ADDENDUM NO.:TWODATE: February 26, 2015PROJECT TITLE:OUTDOOR EVENTS SHELTER
UNC CHARLOTTE
SCO ID# 14-11196-01A
WTS Project No. 1432/ File 7.0Second State
StateWRITTEN BY:Michael Watson, AIA, LEED AP BD+CSecond State
StateTO:Prospective Bidders / Plan Holders

1. M1.1 MECHANICAL PLAN

RE: Outdoor Events Shelter UNC Charlotte

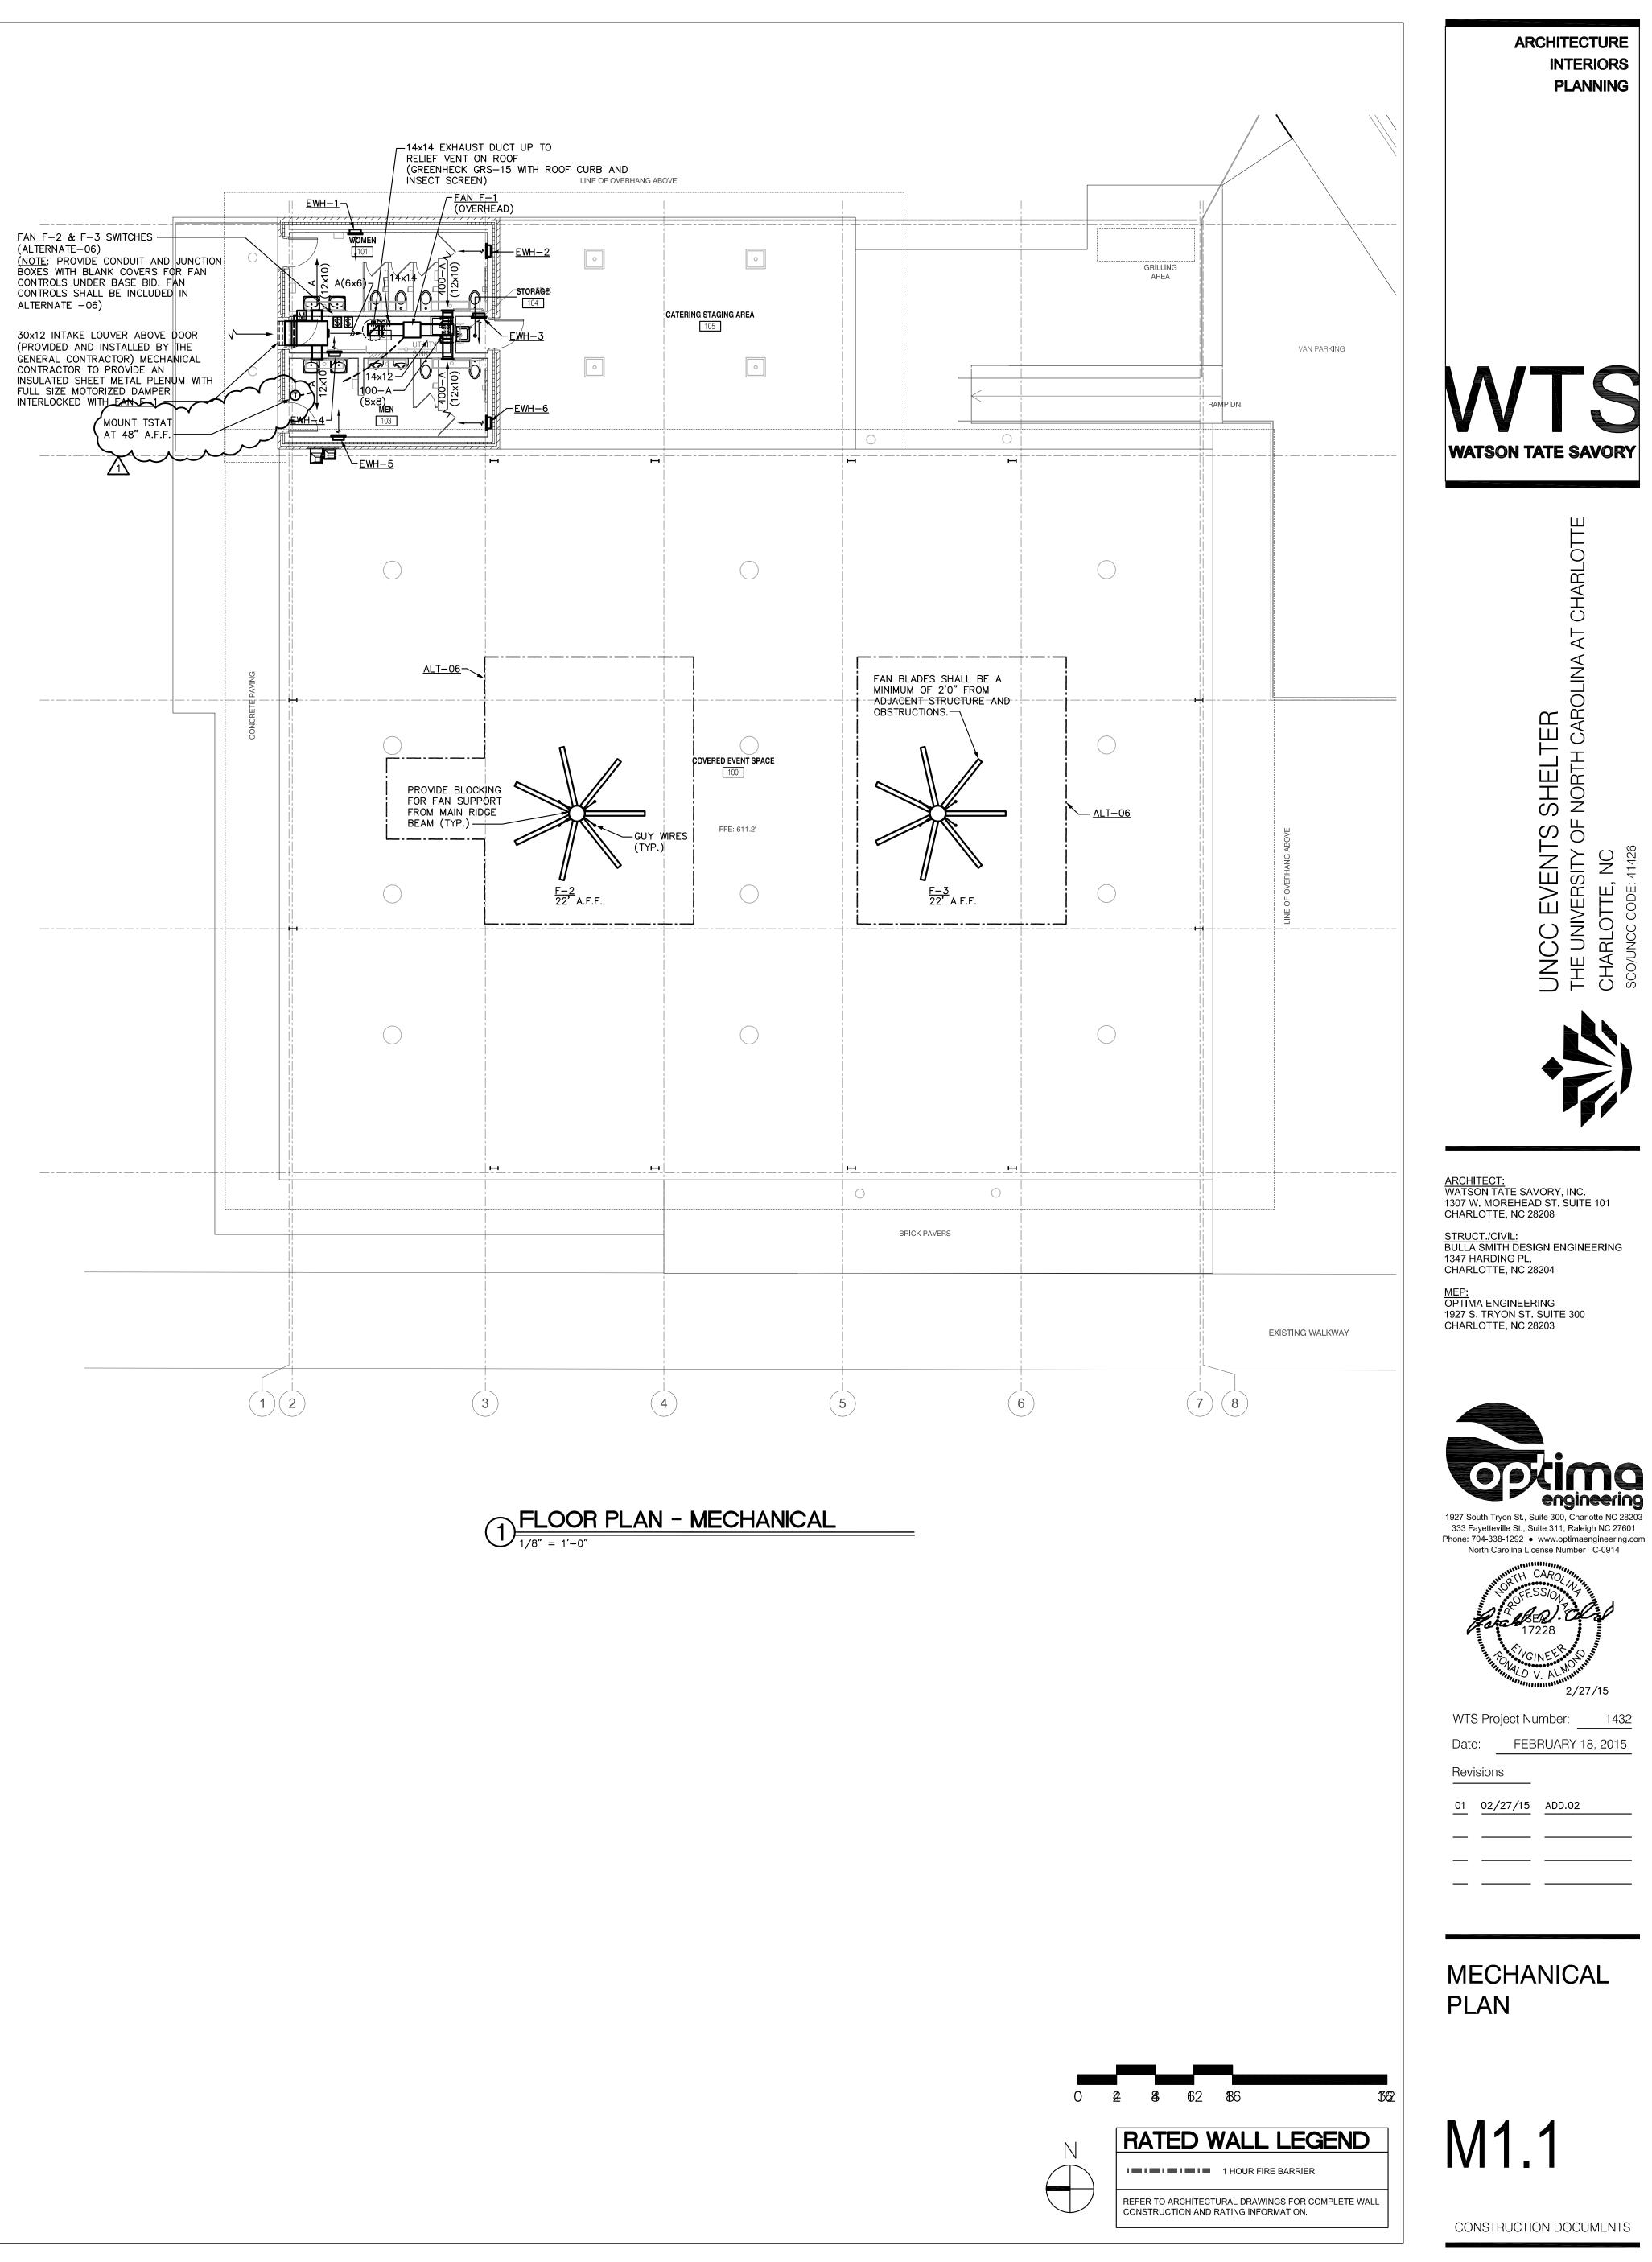
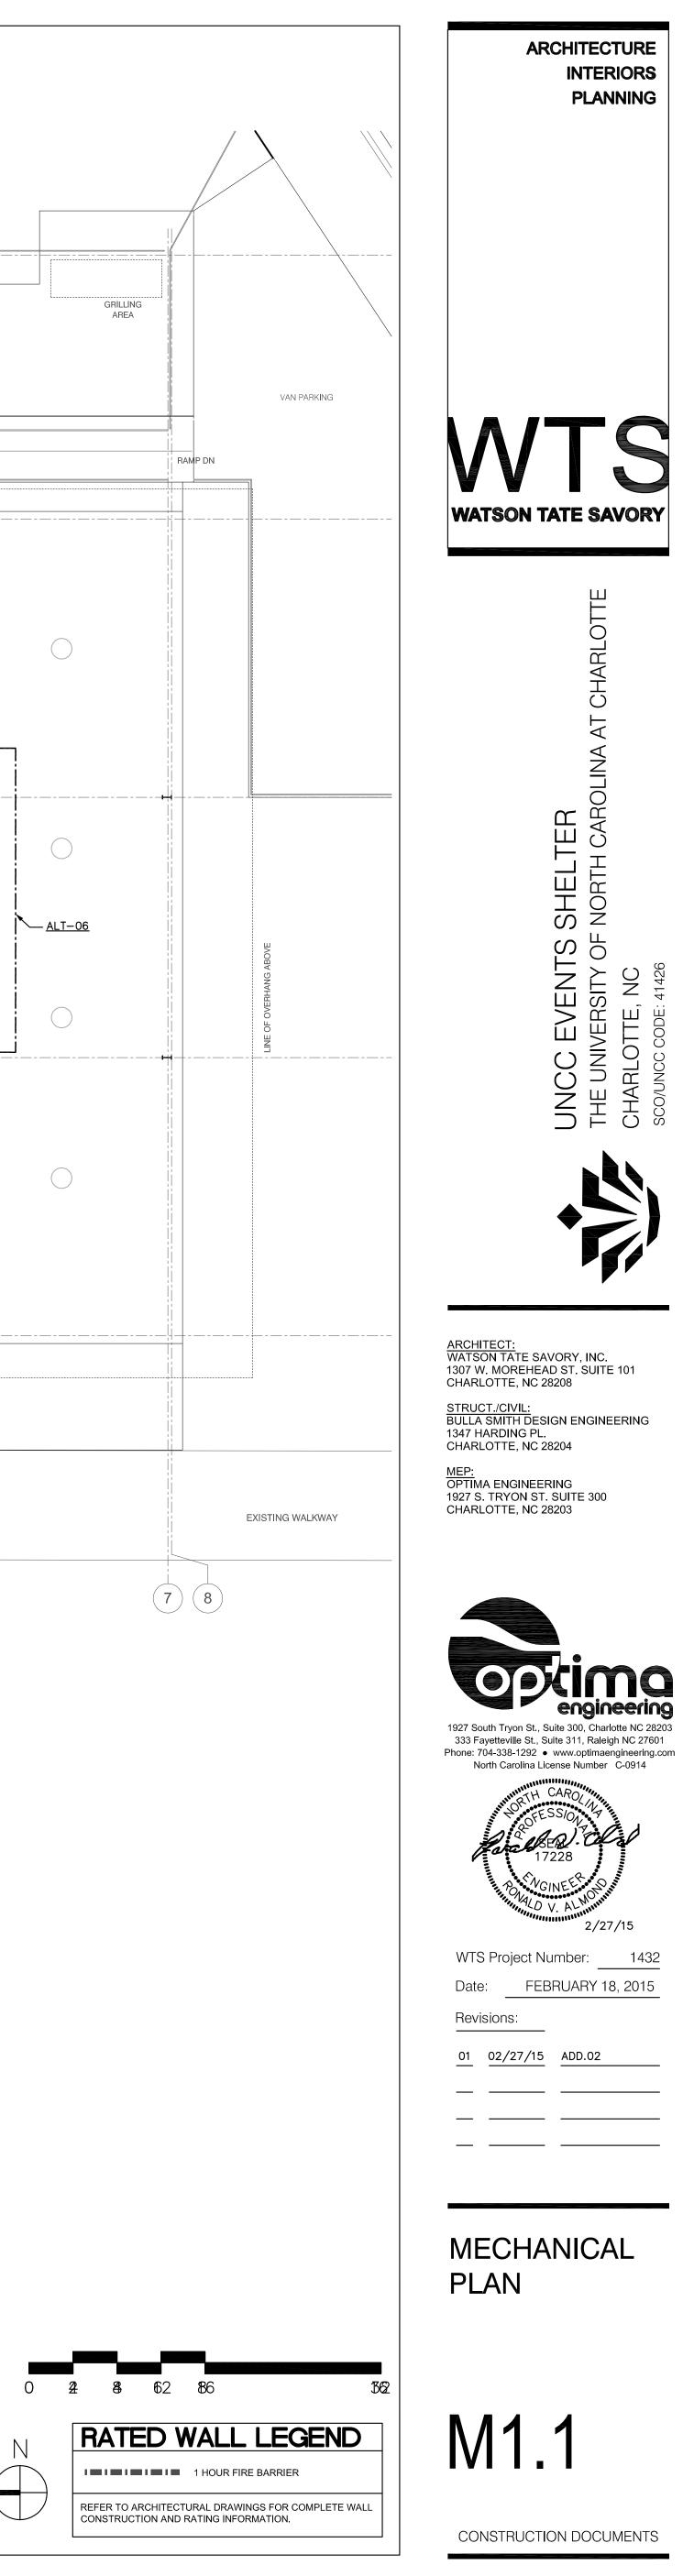
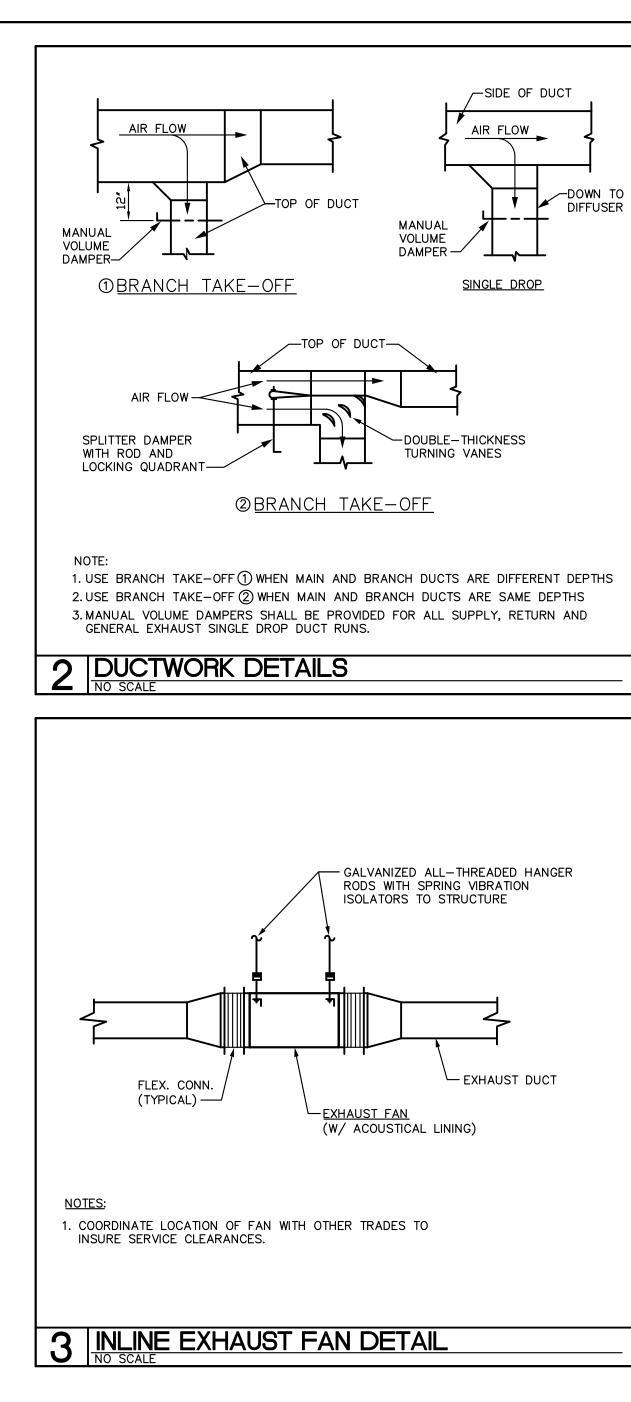
- A. Fans F-2 and F-3 shall be listed and labeled for damp locations.
- B. Mount TSTAT at 48" A.F.F.

5. FANS (F-2 & F-3) SHALL BE LISTED AND LABELED FOR DAMP LOCATIONS
